Access Compliance Report

Public Rights-of-Way

Intersection ID: 11564	Main Street: BRIXTON_CT	Cross Street: HILLIARD_DR	Location: SW
ADA ID: 13D2F837DF72	Ramp Type: Perp	Initial Pass/Fail: Fail	Overall Compliance: No
		Severity Score: 10

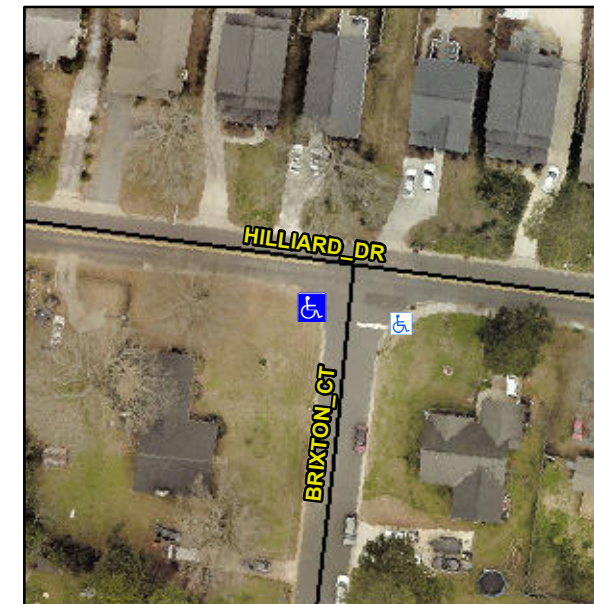
Not Found, R304.5.1, R304.5.3

Compliance	Description	Data	Compliance	Description	Data
N/A	Ramp Length (in)	58.0	Yes	Ramp Slope (%)	6.3
No	Ramp Width (in)	38.5	No	Ramp XSlope (%)	3.6
N/A	Flare Type LT	N/A	N/A	Flare Type RT	N/A
N/A	Flare Slope LT (%)	N/A	N/A	Flare Slope RT (%)	N/A
N/A	Flare Traversable LT?	N/A	N/A	Flare Traversable RT?	N/A
N/A	Landing Length (in)	N/A	N/A	DWS Provided?	N/A
N/A	Landing Width (in)	N/A	N/A	DWS Contrast?	N/A
N/A	Landing Slope (%)	N/A	N/A	DWS Length (in)	N/A
N/A	Landing X Slope (%)	N/A	N/A	DWS Full Width?	N/A
N/A	Landing Curb? (Y/N)	N/A	N/A	DWS Offset (in)	N/A
N/A	Shared Landing?	N/A			
N/A	Gutter Ponding?	N/A	N/A	Gutter Slope (%)	N/A
N/A	Gutter Lip Ht (in)	N/A	N/A	Gutter X Slope (%)	N/A
N/A	Painted X Walk1?	No	N/A	Painted X Walk2?	N/A
	X Walk 1 Direction	To E		X Walk 2 Direction	N/A
N/A	X Walk 1 Width (in)	N/A	N/A	X Walk 2 Width (in)	N/A
	X Walk 1 Slope (%)	0.5		X Walk 2 Slope (%)	N/A
	X Walk 1 X Slope (%)	3.5		X Walk 2 X Slope (%)	N/A

Remove & Replace Entire Ramp.
